**Studies of Nuclear Hazards
and Constitutional Law**

Subject: Second Postscript for Notes of Tele-conference 9 January 2006 --
Three Mile Island Reactor Accident:
The Significance of the large Temperature Difference between the
inlet and outlet Reactor Coolant of the TMI-2 Reactor at 18 Hours
into the Accident; and
the Inadequacies of the Post-Accident Reactor Examination and the
official Analysis of what happened in the Accident.

Fig. 1 TMI-2 reactor vessel end-state configuration.

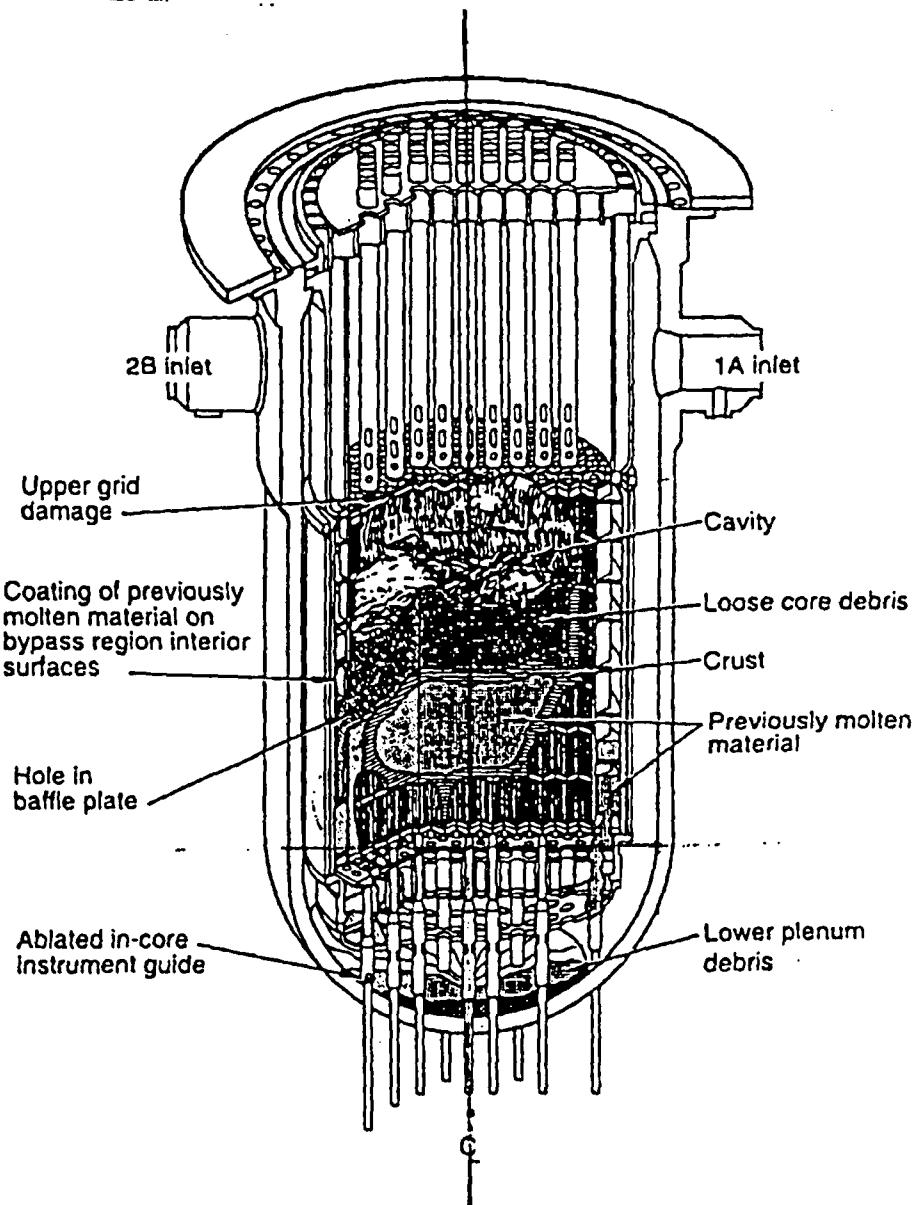
The A-Loop cold legs drew their water from the plenum of the A-Loop Steam Generator, and yet the temperature of the 2A leg is higher, and much higher, than the leg 1A. I assume that there is a back flow through the 2A pump, since it was not running. So, I think that there must have been a hole in the core barrel such that the coolant flow that went up into the core, coming from the discharge of the 1A pump that was running, divided into two branches: one branch flowed up and out of the core, being heated in the process, to explain the 325 °F hot leg temperatures; while the other branch exited the postulated hole, to enter the inlet nozzle for the 2A leg. The 2nd branch of core flow formed a part of the back flow through the 2A pump. Having flowed through much of the core region, that back flow was heated by the core decay heat. The Rogovin Report, page 490, gives a schematic drawing of the TMI-2 reactor coolant system, and that shows that the reactor vessel inlet nozzle from the 2A cold leg is almost diametrically opposite from

the inlet nozzle of the 1A cold leg; and indeed, the drawing of the "end-state configuration" of the TMI reactor core and vessel internals given in the August 1989 Nuclear Technology article on "A Scenario ..." by Broughton and others, reprinted in Nuclear Safety, Vol. 35, No. 2, shows a hold in the "baffle plate" at the 2B inlet nozzle side of the vessel; though no hold through the core barrel. Perhaps the flows were very circuitous in the core region, due to a possible massive destruction by then. (This analysis goes further to prove the necessity of leaving a main coolant pump running, and not switch it off.)

I offer a sketch of my idea of a hold in the core barrel; but it represents also a more circuitous path through the core region to the inlet nozzle of 2A. By the way, I assume that the electrical power to the running coolant pump was 6.7 M'W, which is about half of the core decay heat; and the rise in temperature of the coolant due to that electric power would be about 0.5 degrees Fahrenheit, if the flow were 28 million pounds per hour, which I doubt. I am wondering what basis the Rogovin commission asserted that flow value?
